South Texas Project Electric Generating Station 4000 Avenue F – Suite A Bay City, Texas 77414

June 15, 2009  
U7-C-STP-NRC-090056

South Texas Project  
Units 3 and 4  
Docket Nos. 52-012 and 52-013  
Response to Requests for Additional Information

Attached are responses to NRC staff questions included in Request for Additional Information (RAI) letter number 104 related to Combined License Application (COLA) Tier 2 Chapter 7.

Figure 7.2-9 Reactor Protection System IED (Sheet 2 of 11)

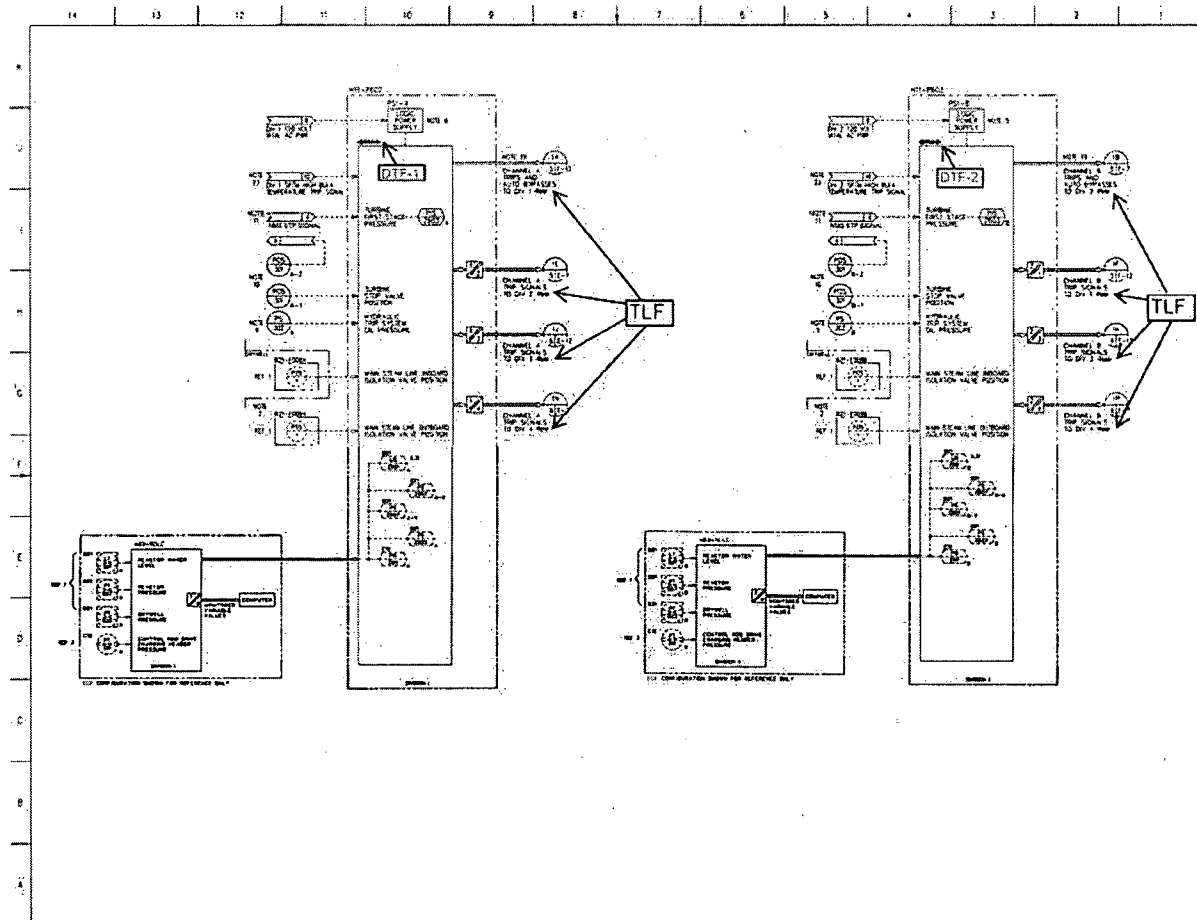
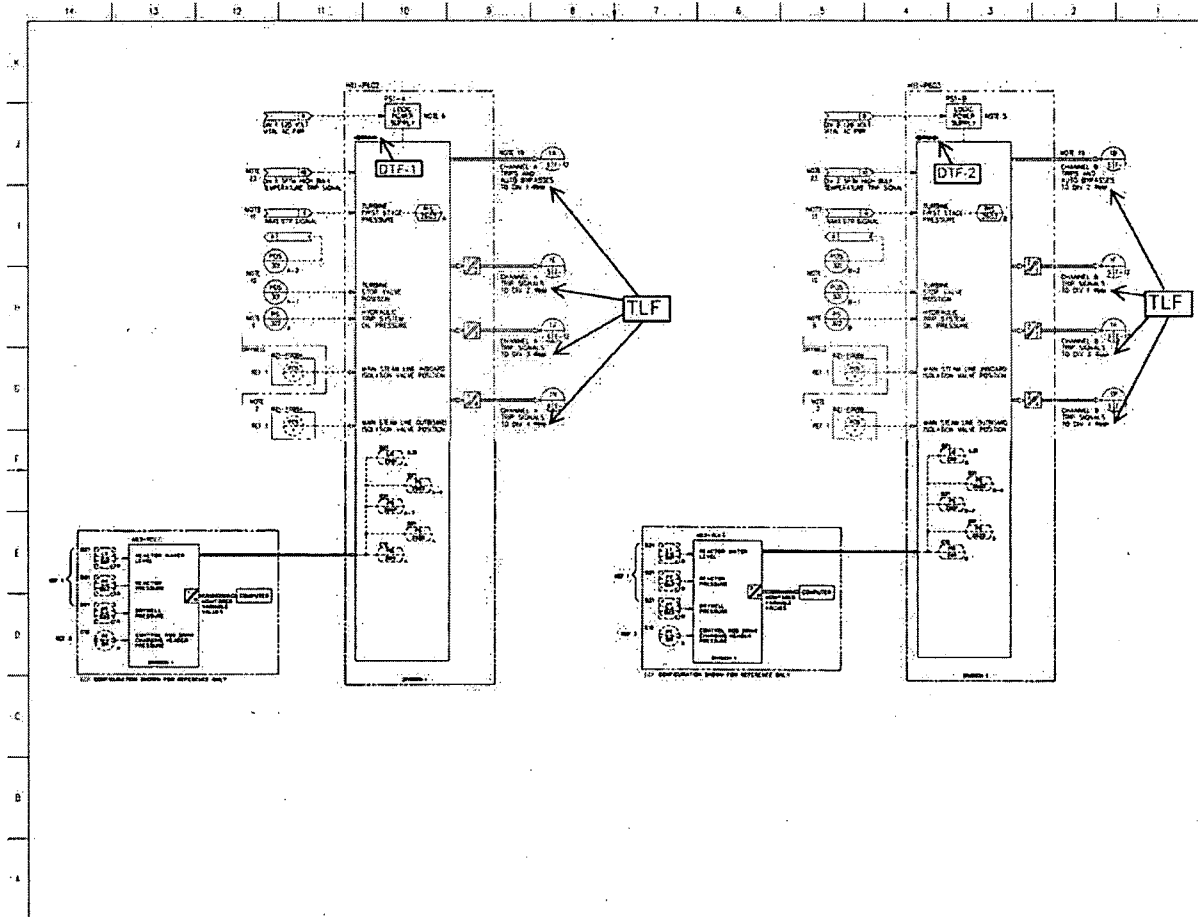
- On FSAR IBD Figure 7.2-9 (Sheet 3), the main steam line (MSL) radiation trip signal is still included. It should be deleted according to STD DEP T1 2.3-1.

- IBD Figures 7.2-9 (sheets 1 -3) and Figure 7.1-2, editorial changes need to be made by using the revised terminology for the COL application, such as DTU, DTM, and TLU which have been changed to DTF and TLF, respectively.

- Bullet Item 6; The main steam line (MSL) radiation trip signal was removed from three of the four divisions on FSAR IED Figure 7.2-9 (Sheets 2 and 3). The remaining trip signal will be deleted from Sheet 3 according to STD DEP T1 2.3-1.

Chapter 21, Figure 7.2-9 Sheets 2 and 3 will be changed as shown below.

Note: Sheets 2 and 3 also require changes to Bullet Item 12. Therefore, all RAI changes are shown in Sheets 2 and 3 here and in Bullet Item 12.

Tier 1, Figure 3.4b

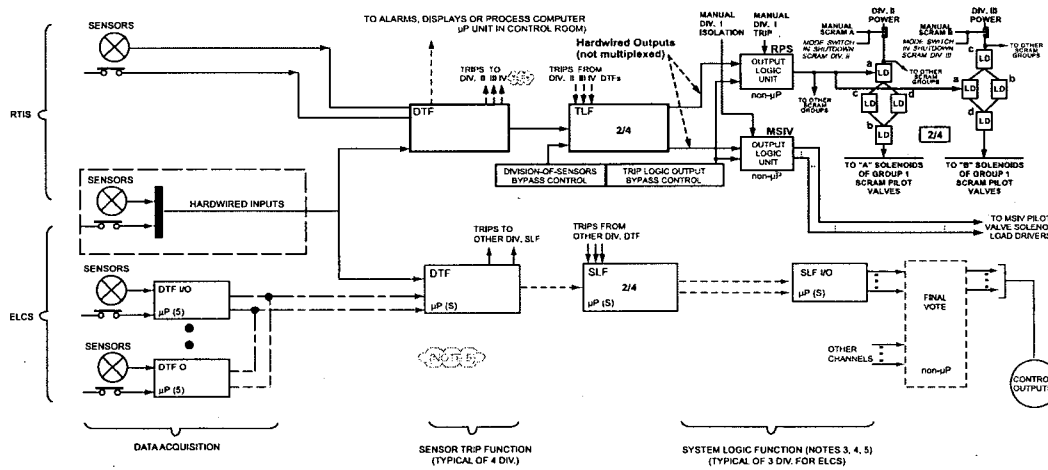
- FSAR Tier 1 Figure 3.4b, TLU still used on the diagram should be changed to TLF, and ELF used in note 4 should be SLF. Provide clarification on what type of equipment will be used for the non-microprocessor based final vote component for the ELCS system.

- Bullet Item 8; FSAR Tier 1 Figure 3.4b, TLU still used on the diagram should be changed to TLF, and ELF used in note 4 should be SLF. Provide clarification on what type of equipment will be used for the non-microprocessor based final vote component for the ELCS system.

The following revised figure will also be provided in COLA Revision 3. It corrects the errors stated in the above question.

Tier 1, Section 3.4 Figure 3.4b will be changed as shown below.

Figure 7.3-2 (Sheet 36)

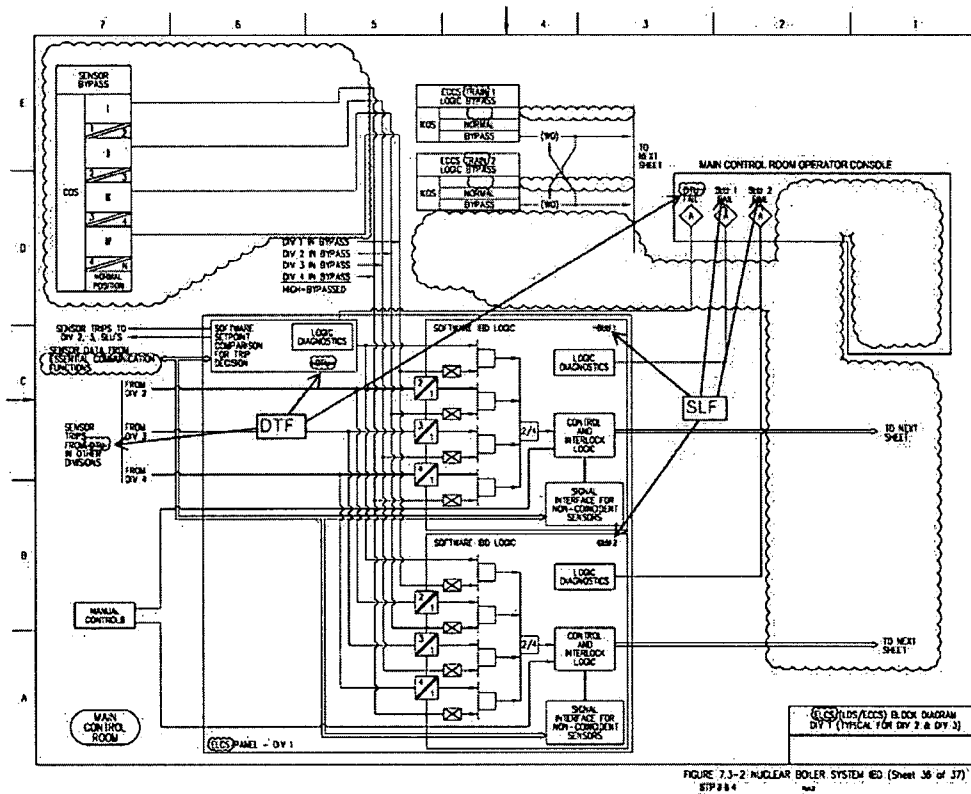
- On IBD Figure 7.3-2, old terminology such as DTU, SLU, etc. is still used on the diagrams. Use the revised terminology.
- MUX is still used on IED Figure 7.7.-2 (sheet 1).

- Bullet Item 9; On IBD Figure 7.3-2, old terminology such as DTU, SLU, etc. is still used on the diagrams. Use the revised terminology.

In Chapter 21 Figure 7.3-2 Nuclear Boiler System IBD Sheets 36 and 37 will be changed as shown below.
